This after-the-fact COA is being submitted to address the issues discovered during the historic inspection on May 1.

NEW DWELLING FOR:
534 EAST 32nd STREET
SAVANNAH, GEORGIA

Certificate of Appropriateness

File No. 25-002207-COA

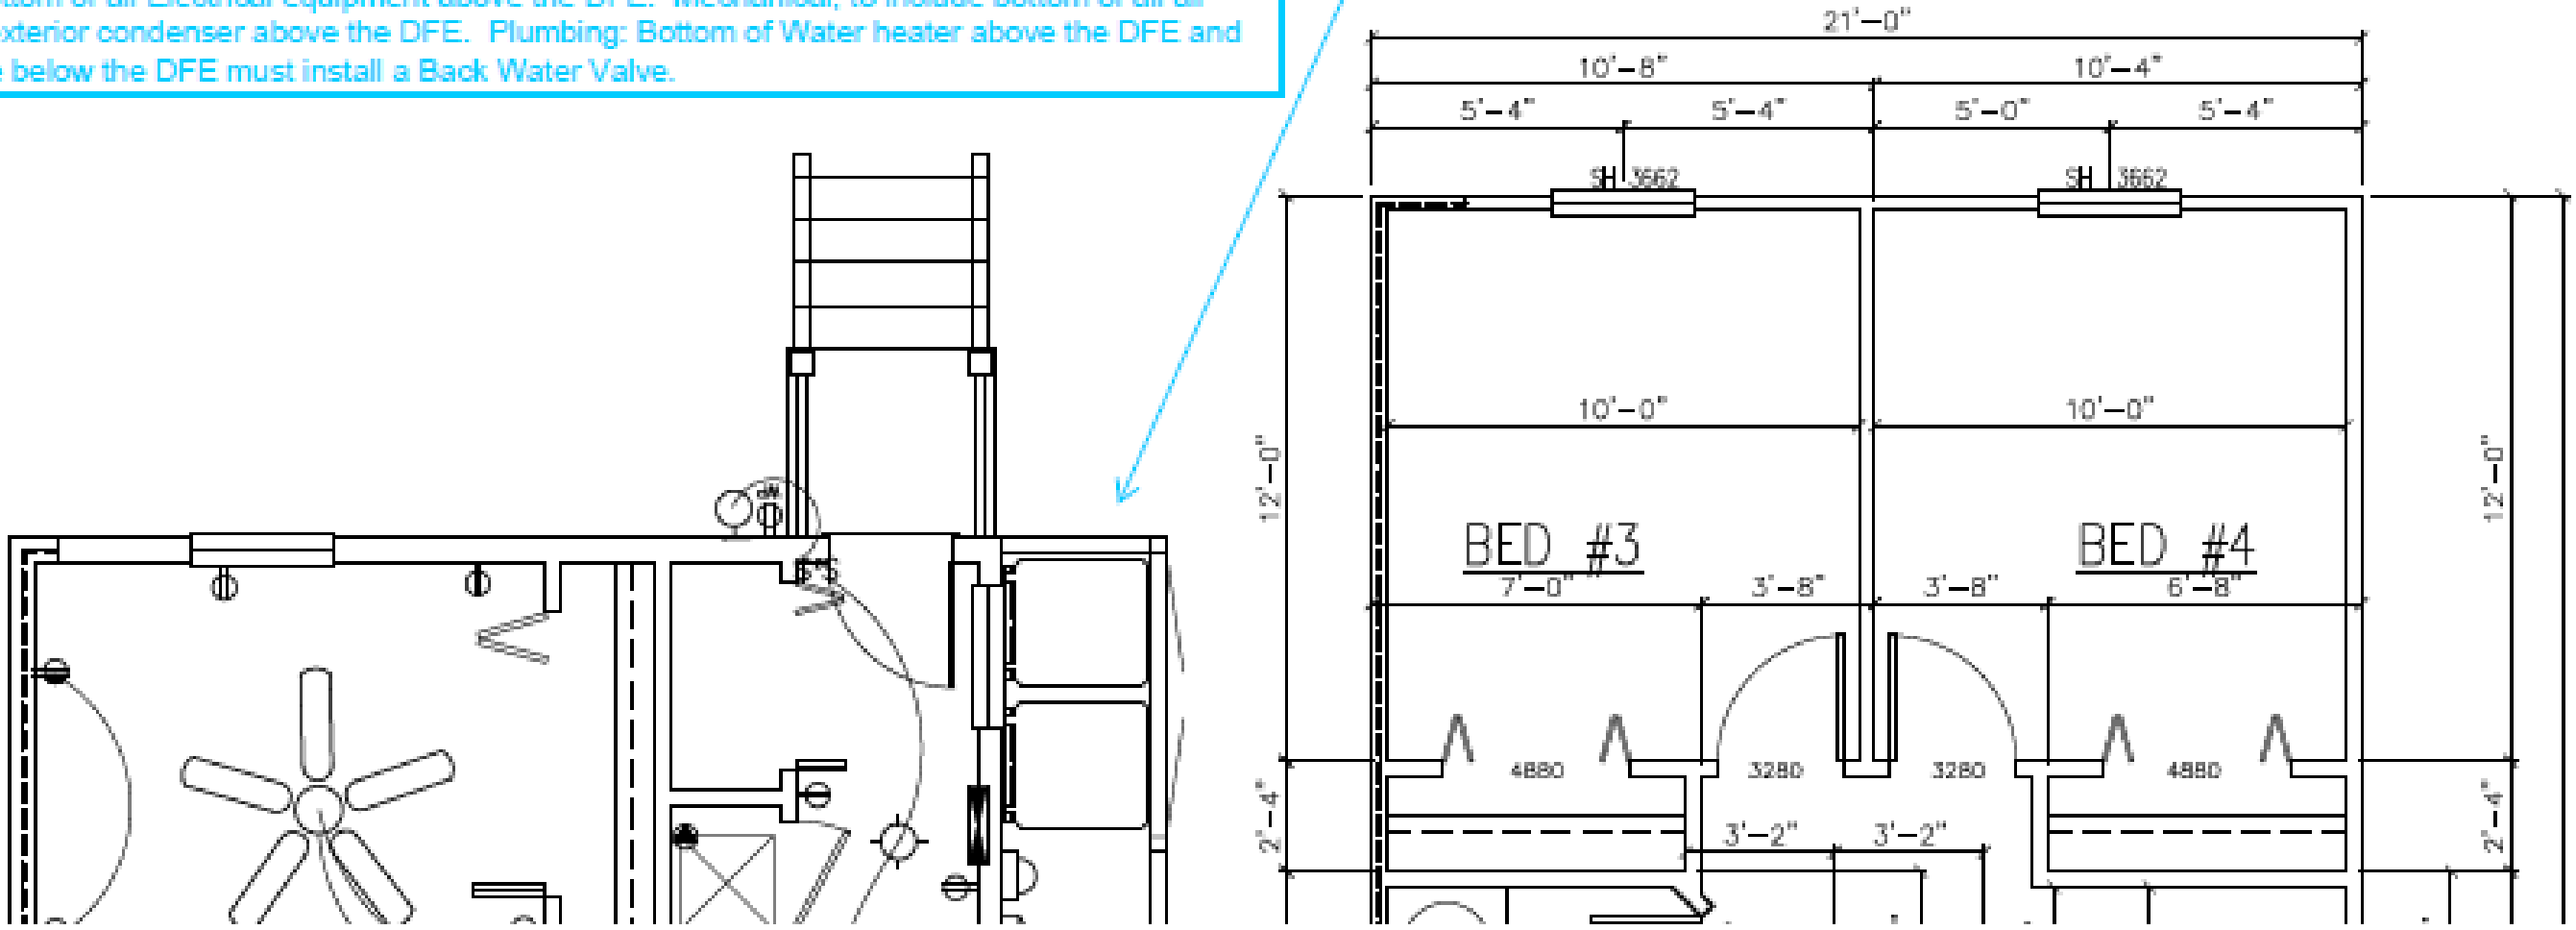
7) During the permitting review, development services required the HVAC to be placed at this specific height.

Prior to Release of the Permanent Power	
NEED	Must provide a FEMA "Finish Construction" Elevation Certificate.
N/A	Need a Recorded Non Conversion Letter. <u>If the Garage is Below the DFE</u>
NEED	Need signed and sealed Compensatory Letter from the engineer of record showing how the amount of displacement materials brought onto the site has been equally balanced by removing at minimum equally quantity of material. * SPR: means a letter is not needed because mitigation will be approved through the Specific or Full Site Permit.
If have engineered hydrostatic vents, need the manufactures specification sheet. Shall have hydrostatic vents on two exterior walls.	
Only one enclosure allowed below the DFE. Partitioned rooms are not allowed.	
Must meet ASCE 24-14 Flood requirements.	
Trades : Bottom of all Electrical equipment above the DFE. Mechanical, to include bottom of all air ducts and exterior condenser above the DFE. Plumbing: Bottom of Water heater above the DFE and drain/fixture below the DFE must install a Back Water Valve.

Flood Prevention Ordinance Sec. 8-7001:Trades:
Must meet ASCE 24-14, Section 7.0 Utilities requirements
Electrical: No electrical switches, outlets, control boxes, disconnects, and generators below 23.7 NAVD88.
Excluding one switch.
Mechanical: Bottom of duct system and equipment, including exterior condensers above 23.7 NAVD88.

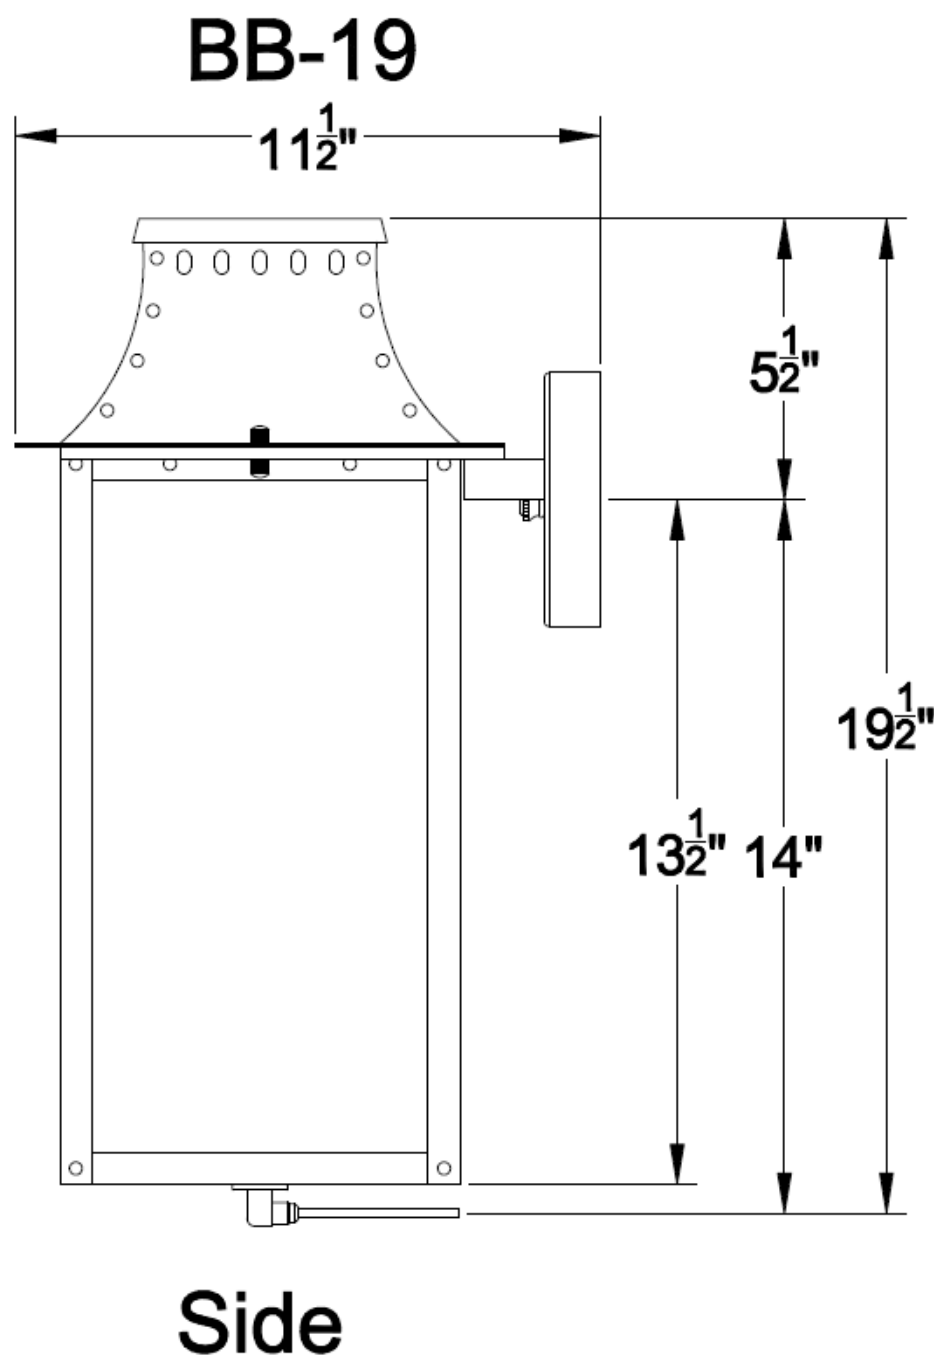
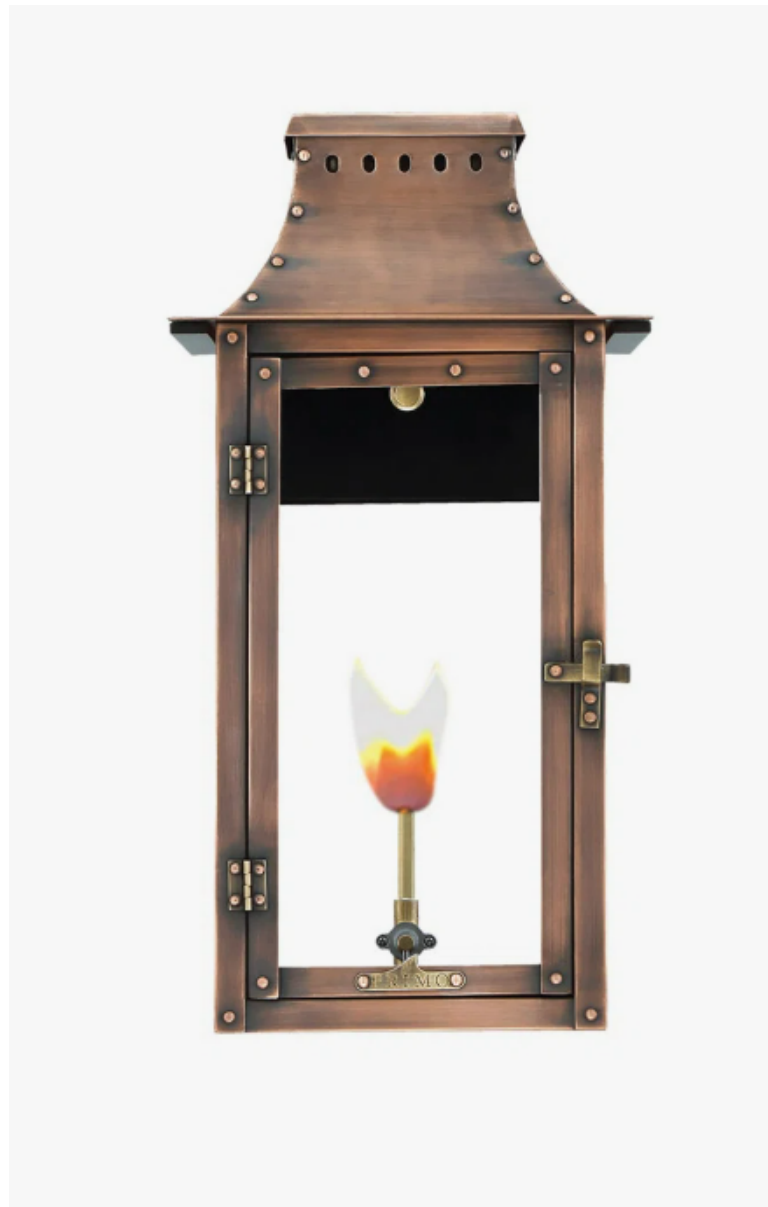
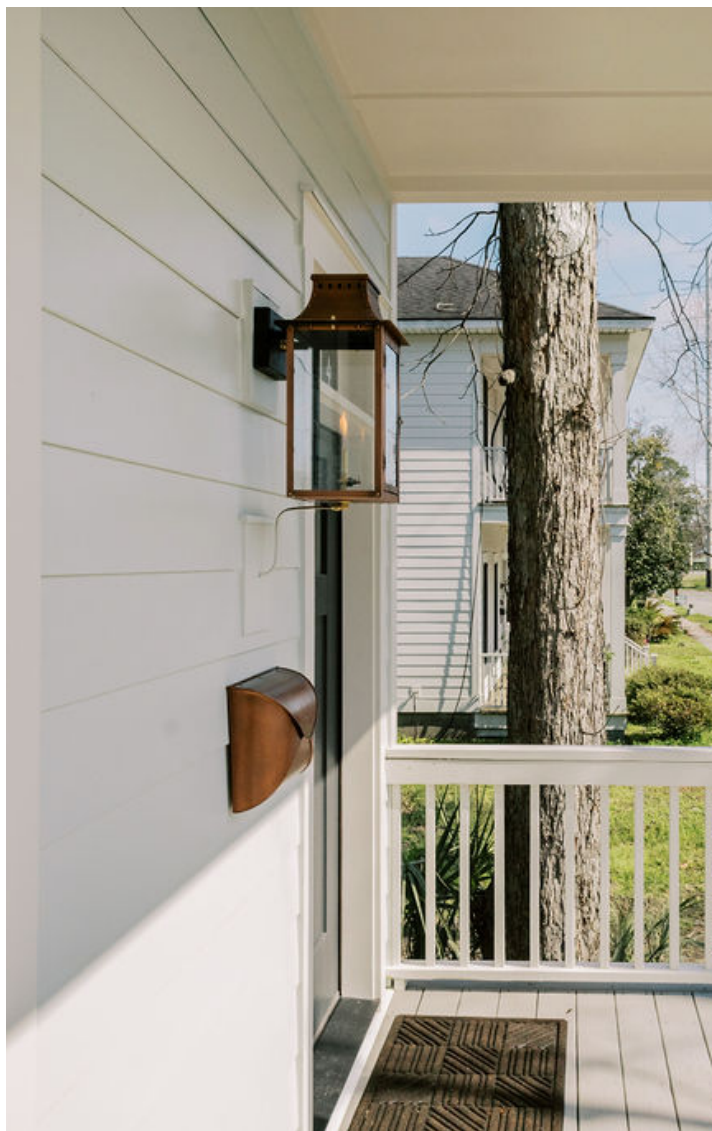
6) Perimeter fence increased based on HVAC location

WEST ELEVATION
SCALE: 1/4" = 1'-0"

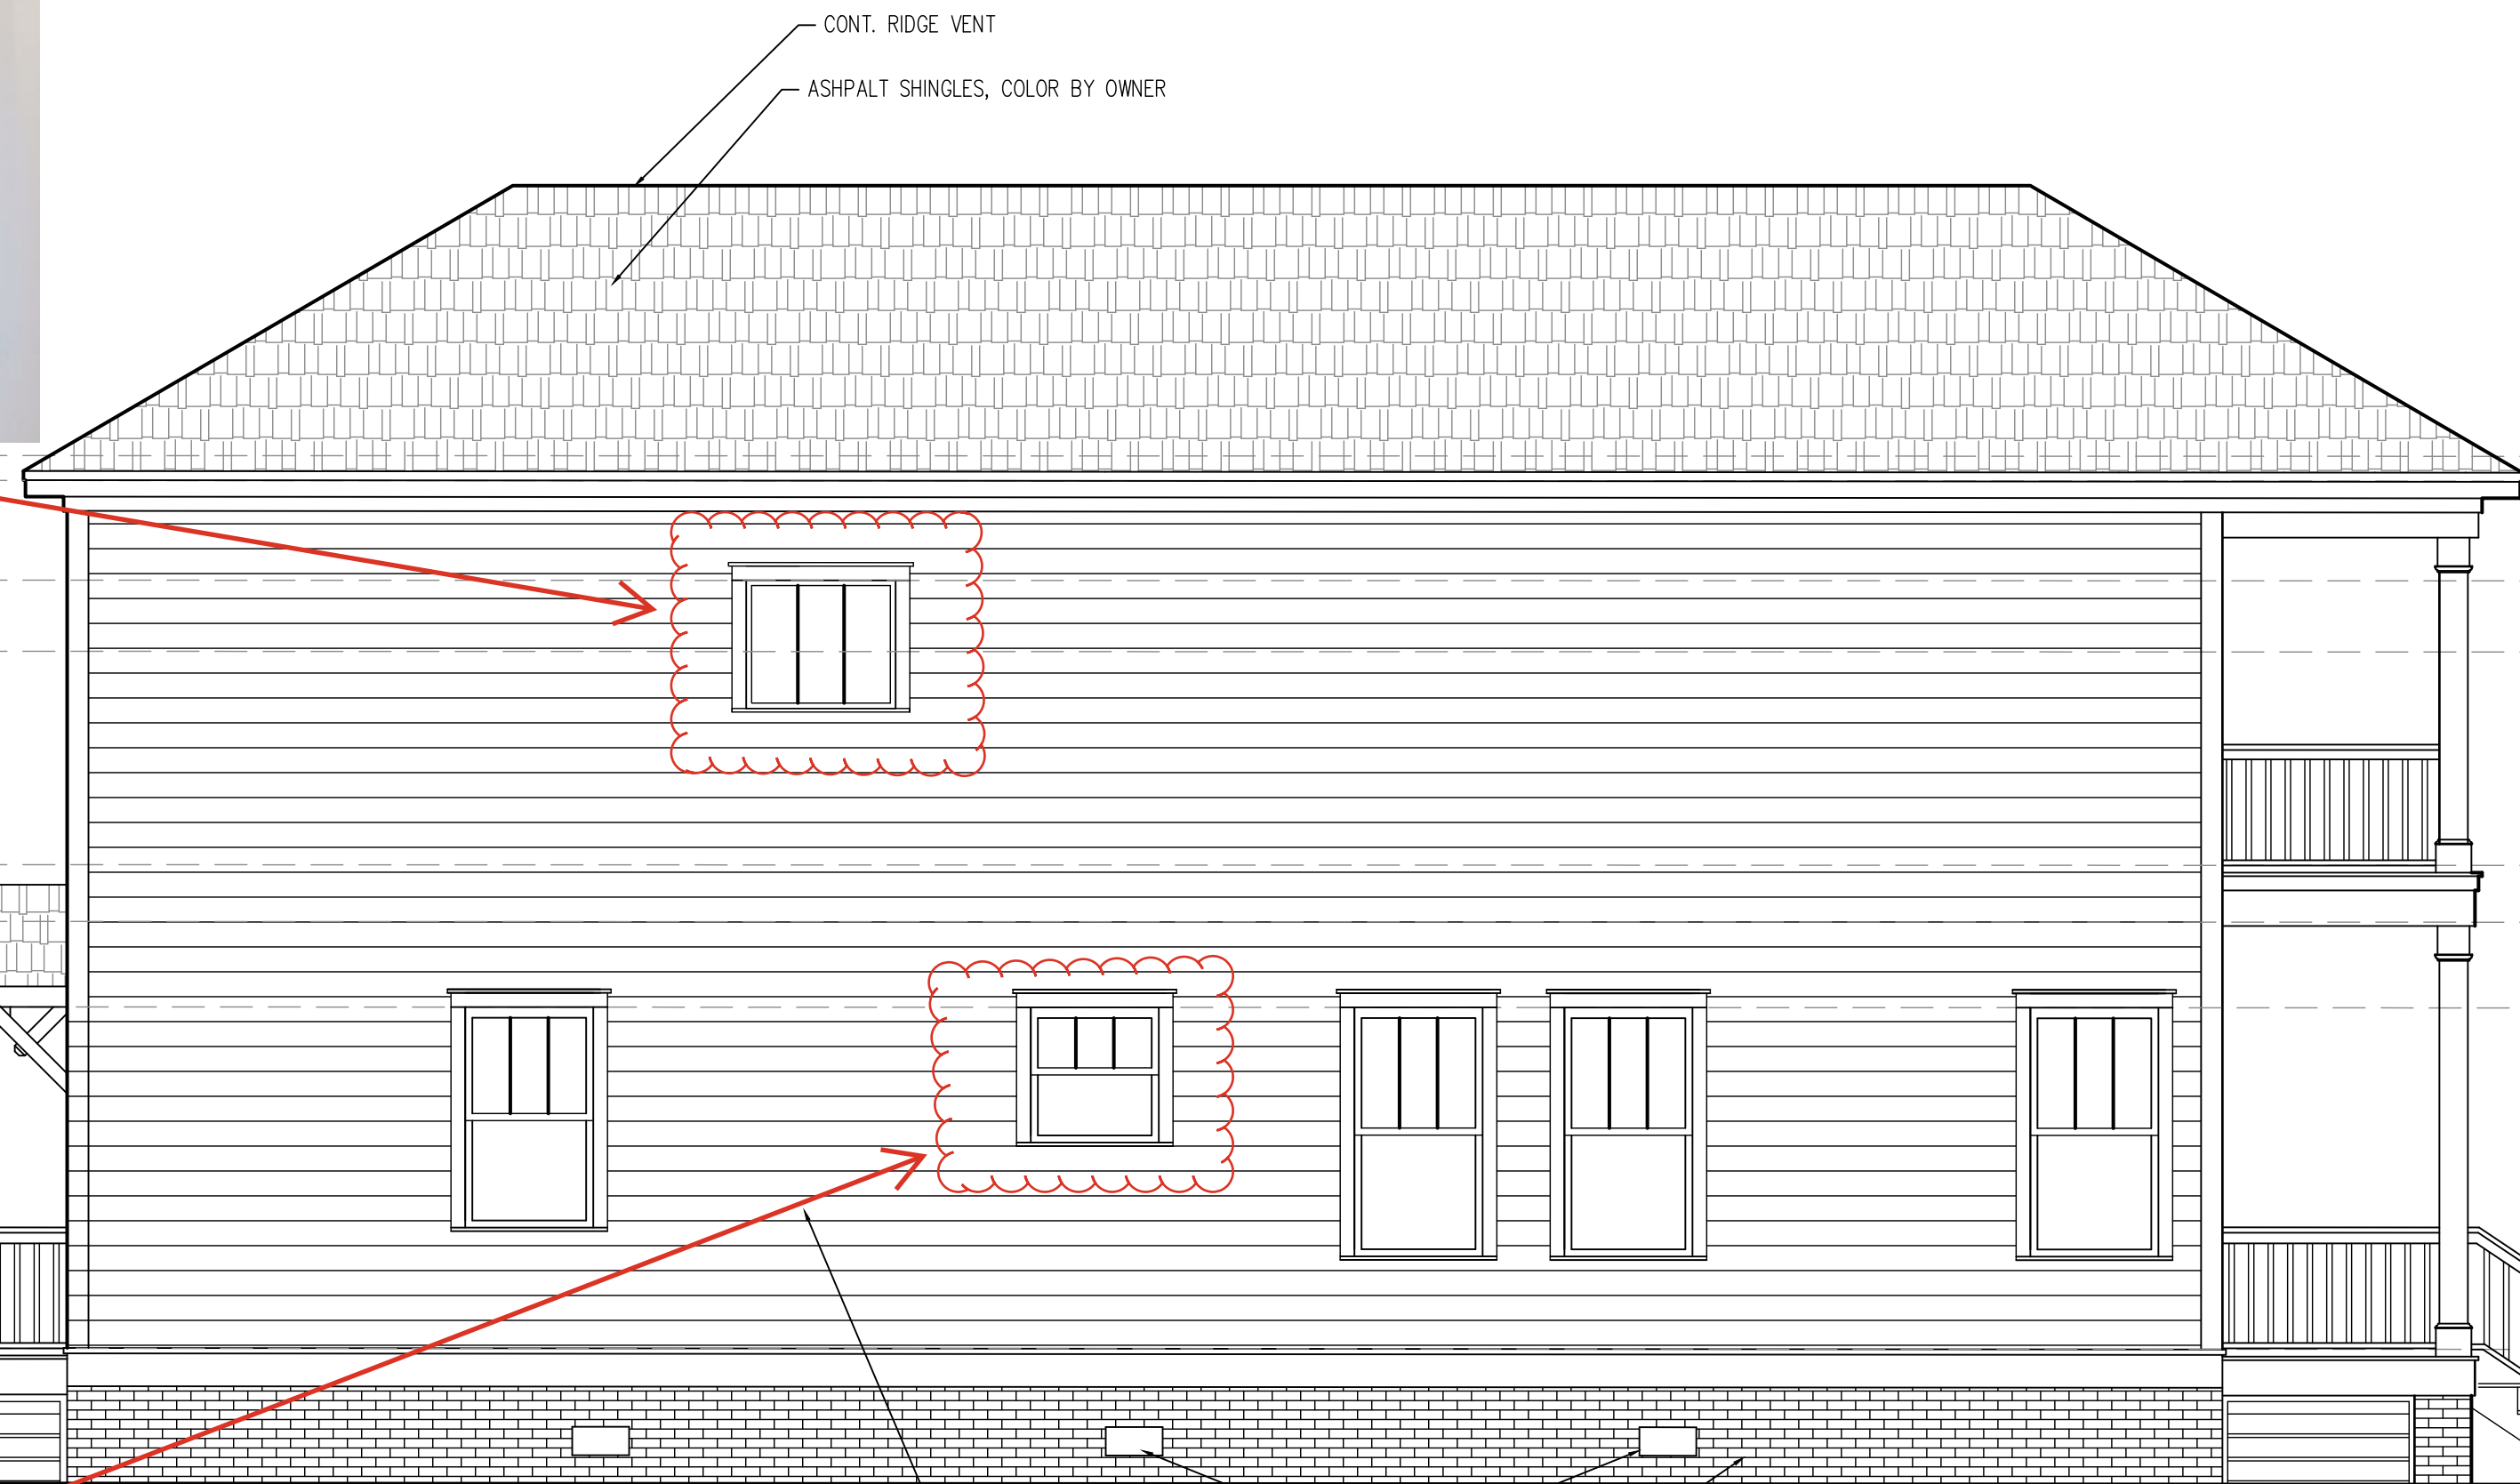
- 1) The window on the 2nd floor on the west facade is different than what was approved. Looks like it was an awning/hopper windows that is now a single hung and slightly larger.
The installed window is 2'0" x 3'0". See attached documents.

1) 2'-0" x 3'-0"
